In the Supreme Court of the United States

No. 141, Original

STATE OF TEXAS, PLAINTIFF

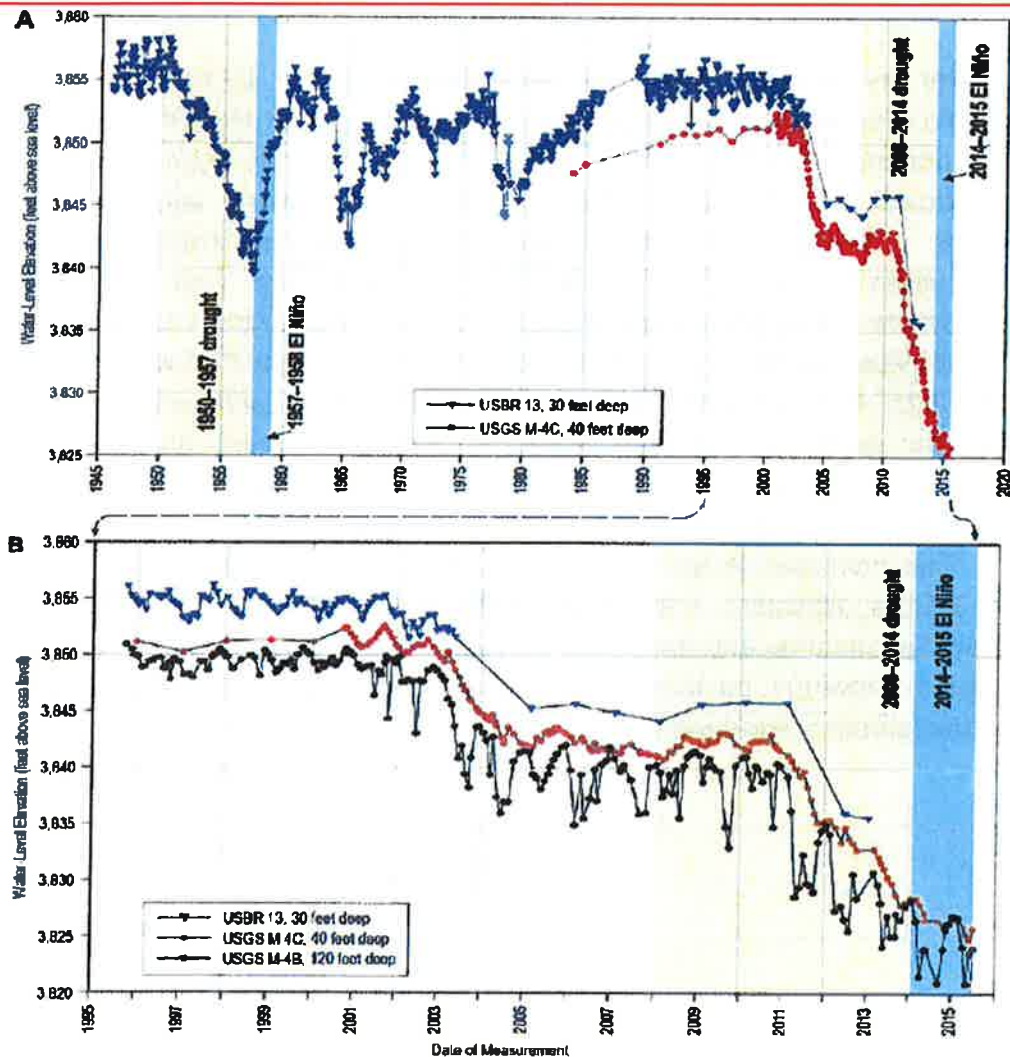
before the current drought (Reclamation 2013a; SEA Appendix F)." This statement fails to acknowledge the realities of water supply under the 2008 Operating Agreement and realistic, historical groundwater trends. Groundwater level trends before 2006 show a consistent historical trend: groundwater declines of 10-15 feet during drought, followed by recovery in full supply years. Since 2006 groundwater levels have shown no recovery during years of full supply to the Project (2008, 2009 and arguably 2010), followed by further decline during the following time of shortage. In short, the effect of 2 the 2008 Operating Agreement is to convert a sustainable aquifer into a mined aquifer.

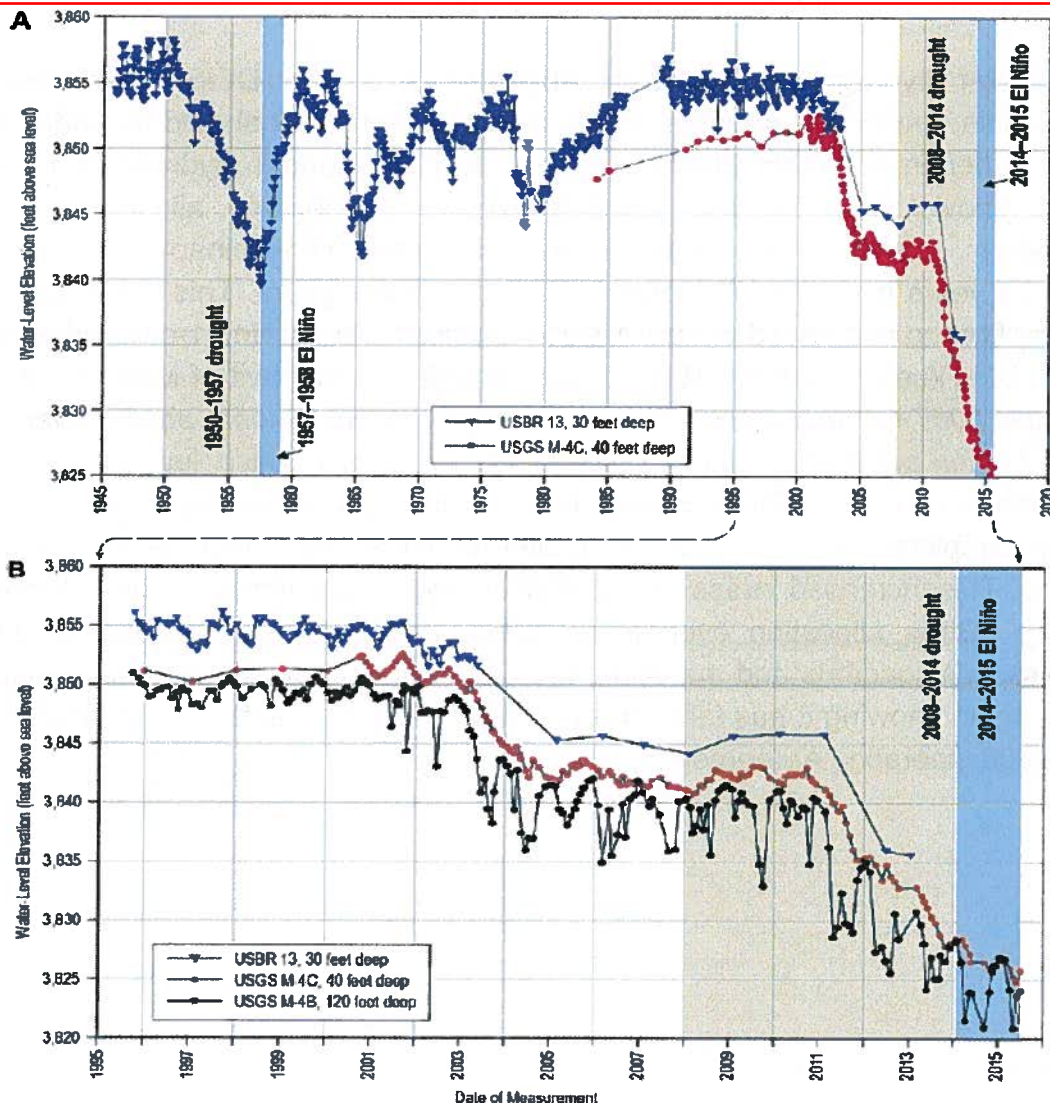
before the current drought (Reclamation 2013a; SEA Appendix F).” This statement fails to acknowledge the realities of water supply under the 2008 Operating Agreement and realistic, historical groundwater trends. Groundwater level trends before 2006 show a consistent historical trend: groundwater declines of 10-15 feet during drought, followed by recovery in full supply years. Since 2006 groundwater levels have shown no recovery during years of full supply to the Project (2008, 2009 and arguably 2010), followed by further decline during the following time of shortage. In short, the effect of the 2008 Operating Agreement is to convert a sustainable aquifer into a mined aquifer.

Figure 1
Number of Wells by Drill Date
El Paso County, Texas
1938 - 2012

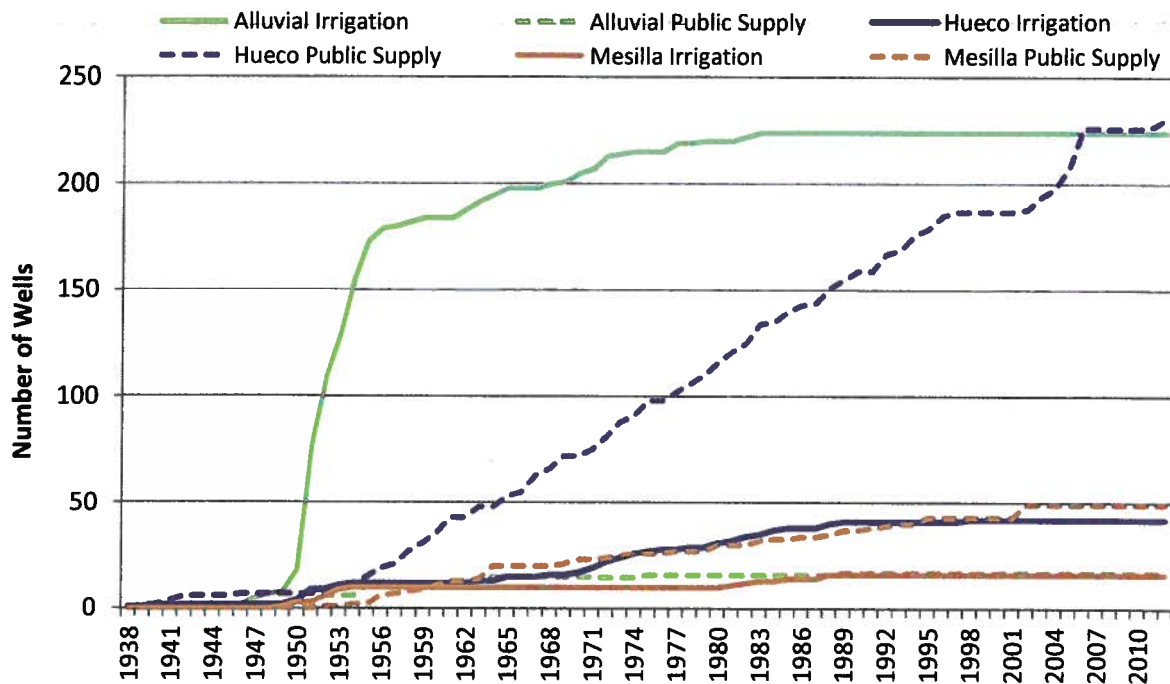
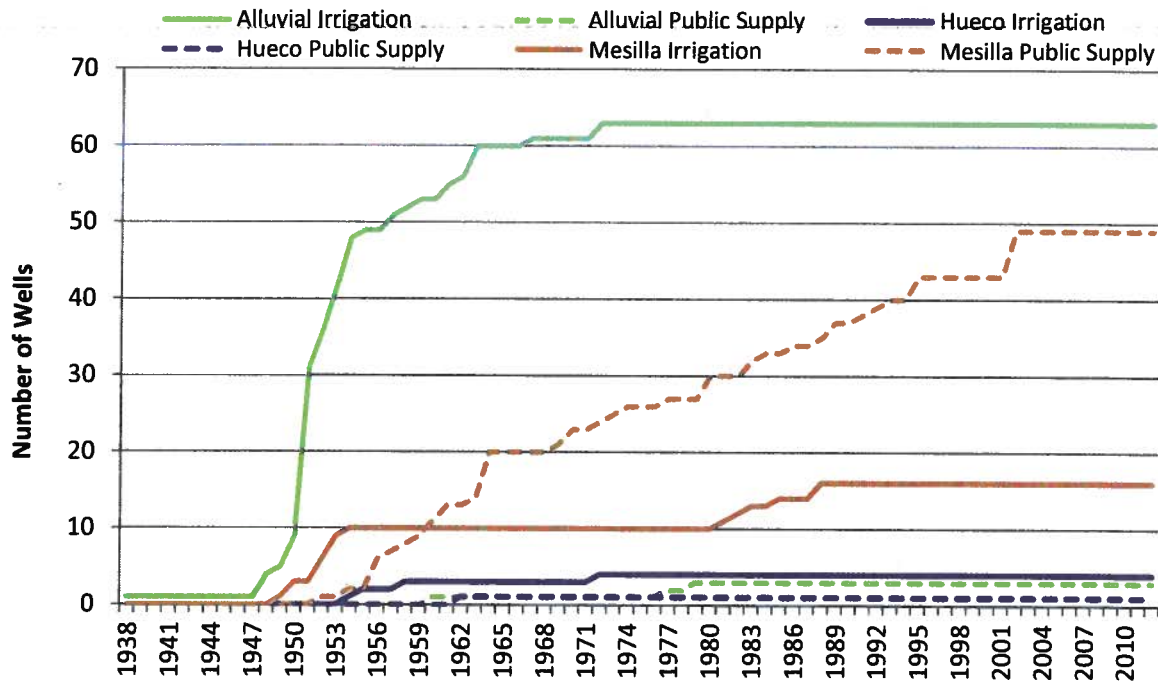
- (2) Pumping Capacity in EPCWID - Contrary to statements in the DEIS, significant irrigation pumping capacity exists in the EPCWID service area. See Figure 1, attached. Therefore, differences in Project supply to EPCWID between the alternatives would result in changes in pumping costs in EPCWID rather than an economic loss of the full value of the water. It is necessary to model the irrigation and municipal water supply operations in the El Paso Valley to assess the

The Texas Water Development Board ("TWDB") maintains a database of wells in the State. Information from this database was downloaded and summarized as shown in Figure 1. The information in the foregoing reports and in the TWDB database indicates there is substantial irrigation pumping in the El Paso Valley, and therefore the assumption that farmers could not pump to replace reductions in Project supply is unreasonable.

Figure 2

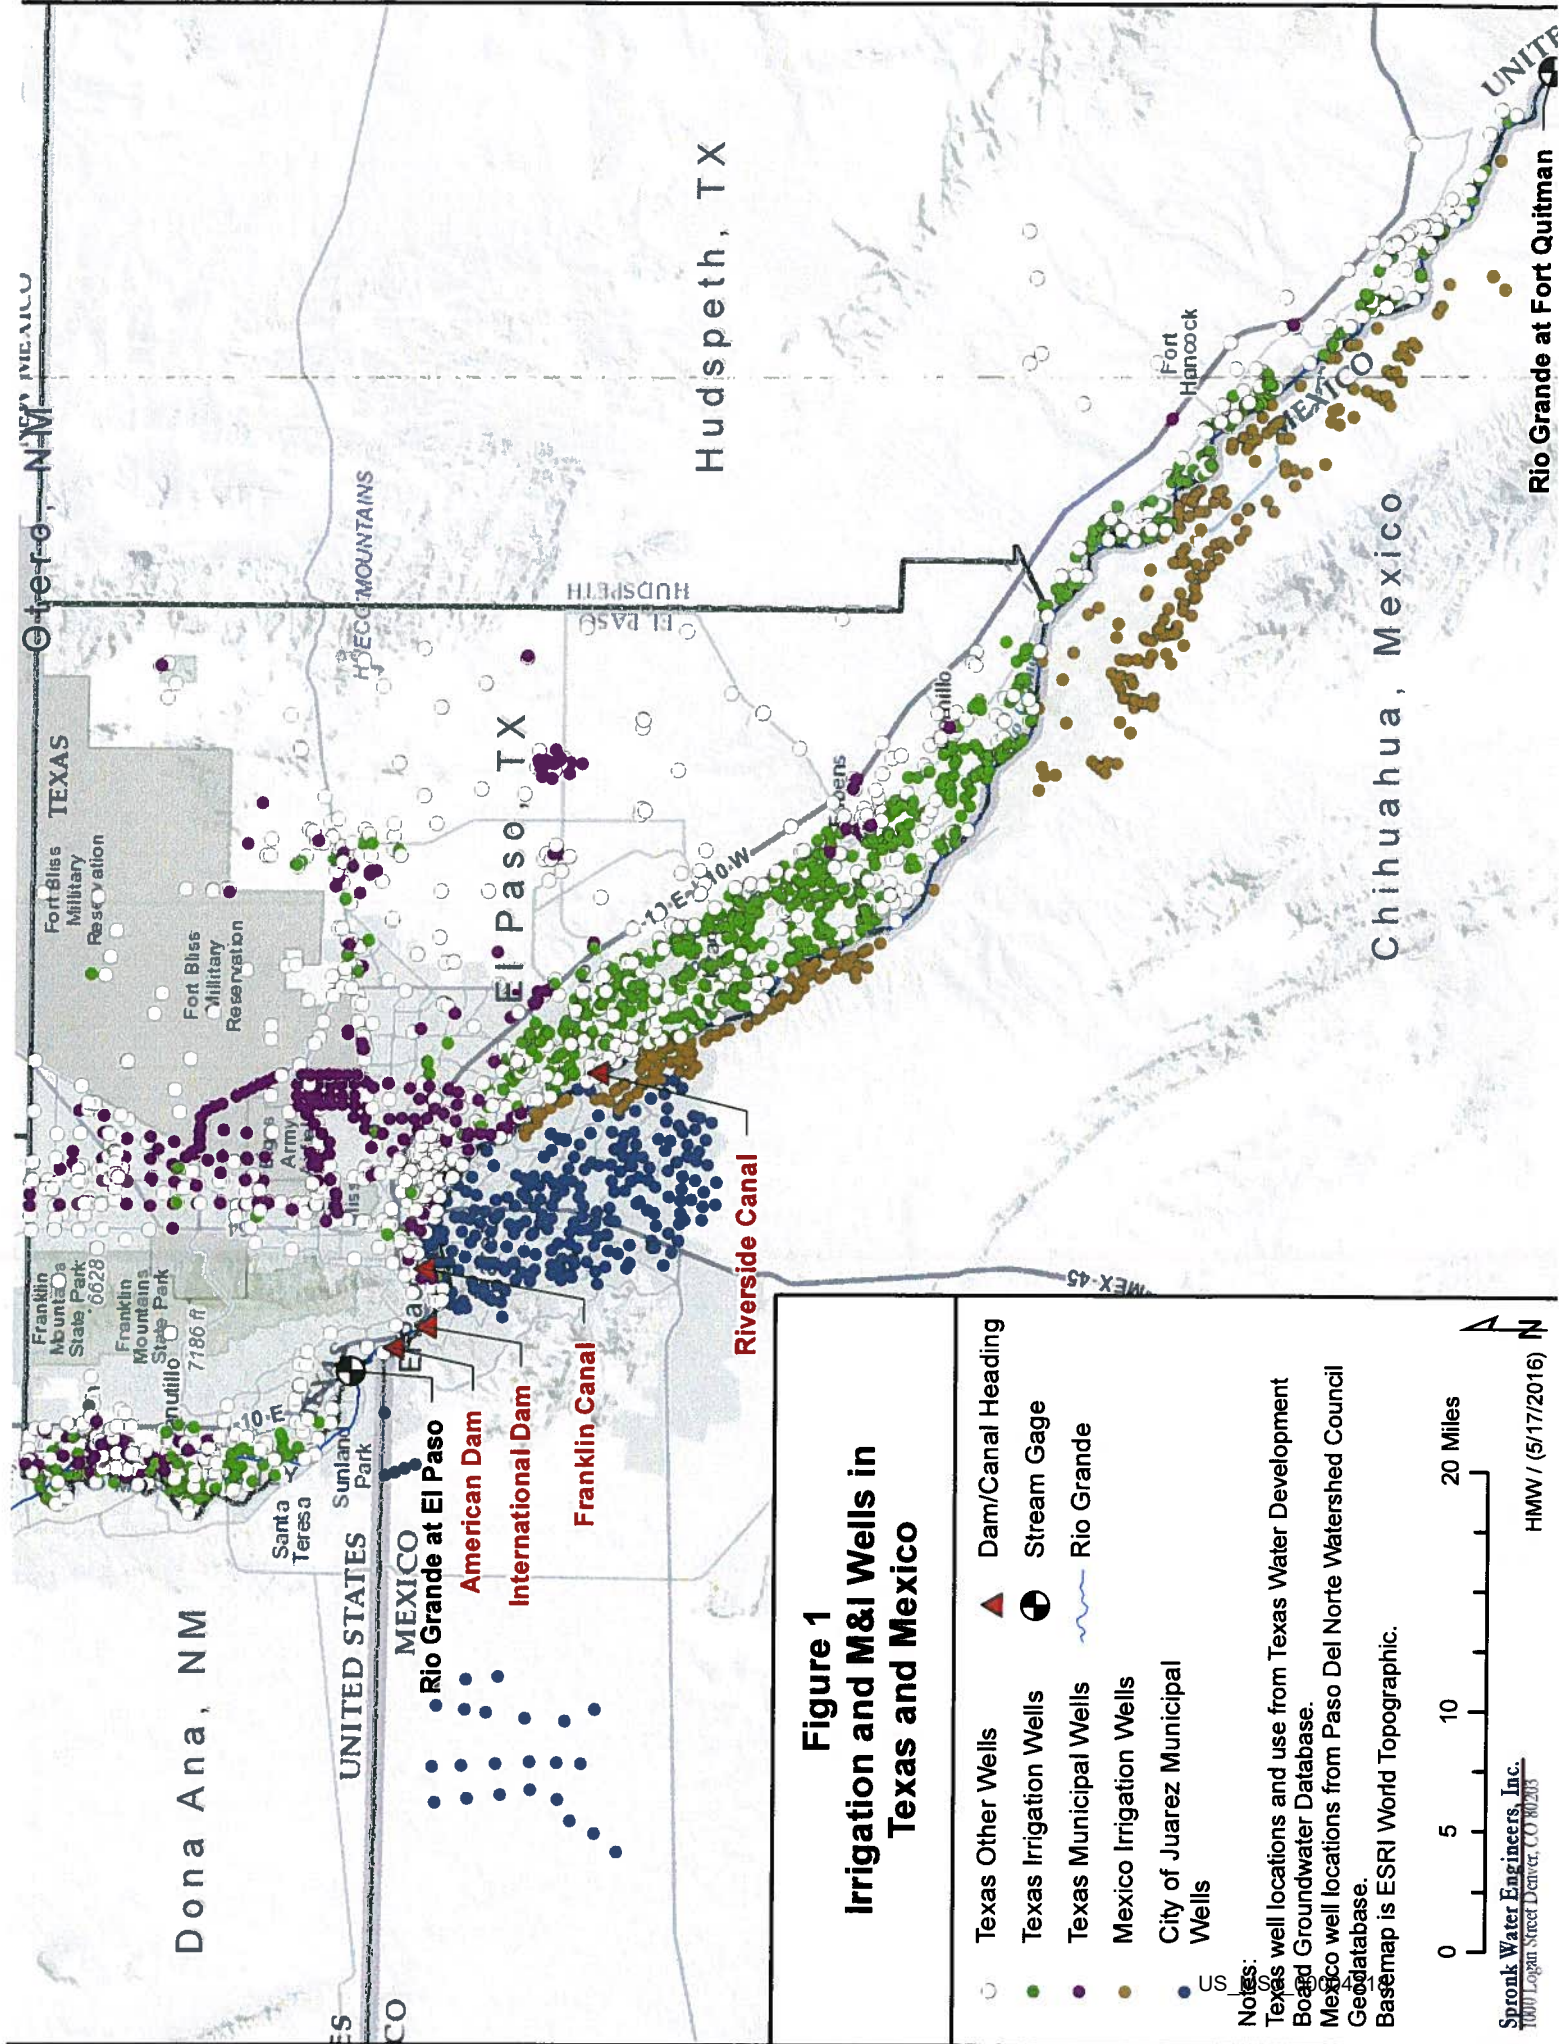
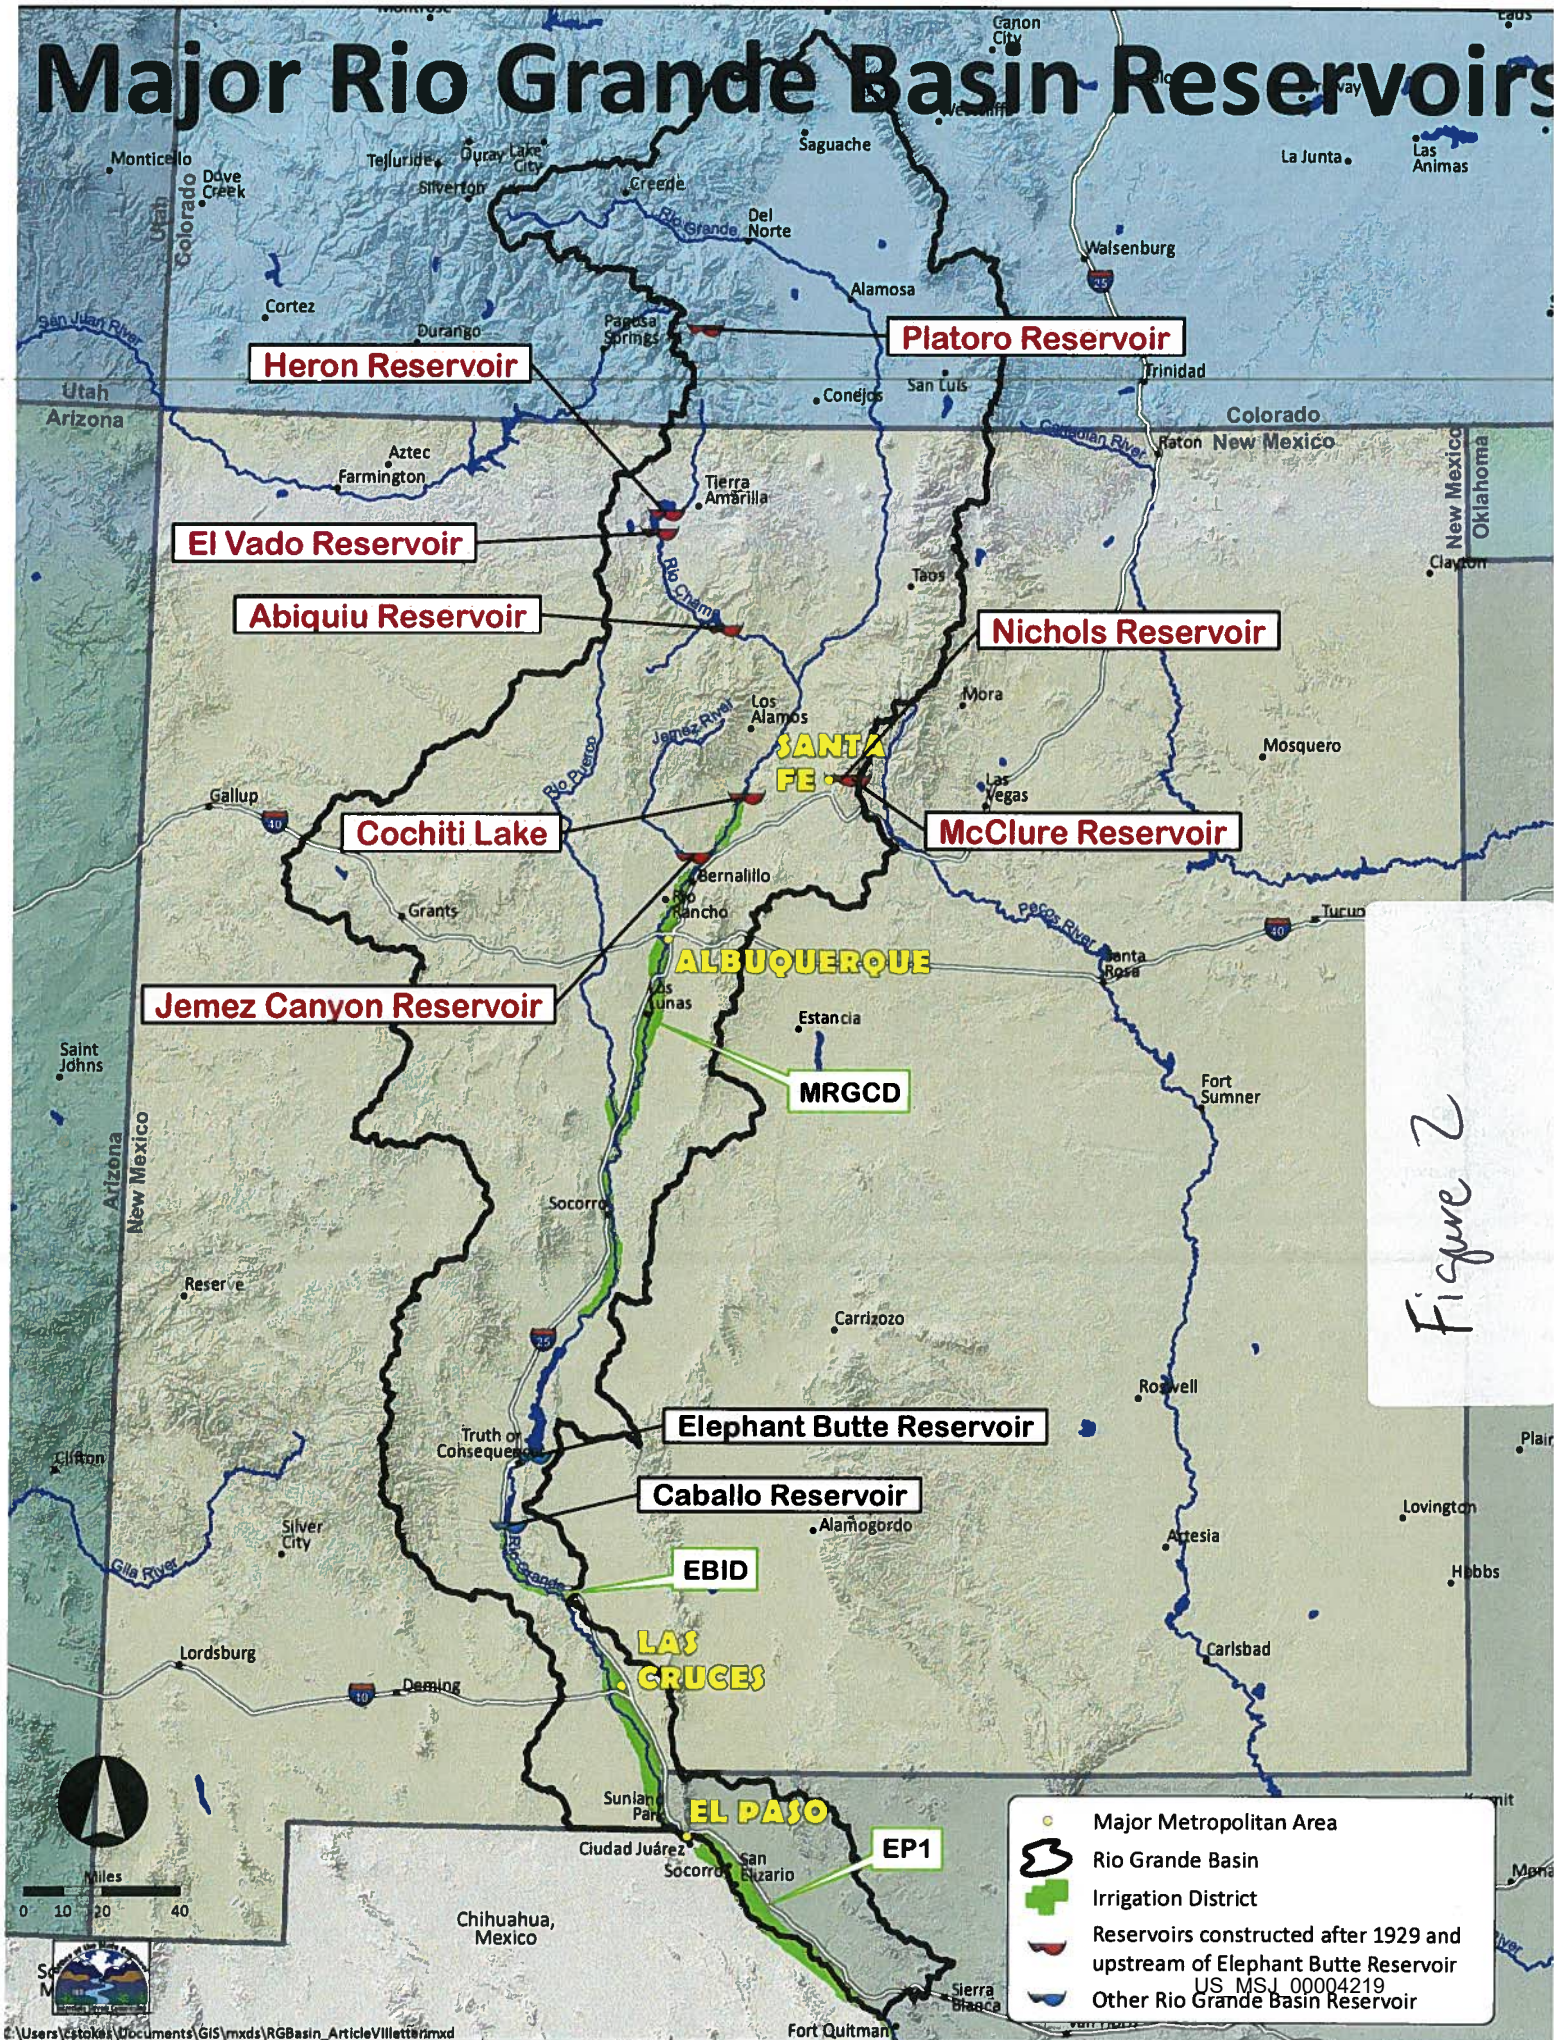
amount of Usable Water in Elephant Butte and Caballo Reservoirs. See Figure 2, map of major Rio Grande Basin reservoirs. The changes listed above impact the timing and duration of Article VII storage restrictions on upstream reservoirs and, consequently, the amount of water that can be stored and released from them. The Middle Rio Grande Basin is dependent upon these upstream reservoirs to meet irrigation demand, to deliver water to municipalities, and to provide water for endangered species in the middle Rio Grande valley of New Mexico. This has specific consequences for reservoirs used to store water for large water users in the middle Rio Grande valley of New Mexico including the Middle Rio Grande Conservancy District, the Albuquerque Bernalillo County Water Utility Authority, and the City of Santa Fe, as well as numerous other water users in New Mexico and Colorado. It also affects releases of water for use by these entities, as well as water releases for the Rio Grande silvery minnow and Southwestern willow flycatcher, and for federally designated critical habitat upstream of EBR. These considerations are hereinafter referred to collectively as "Upstream Impacts."
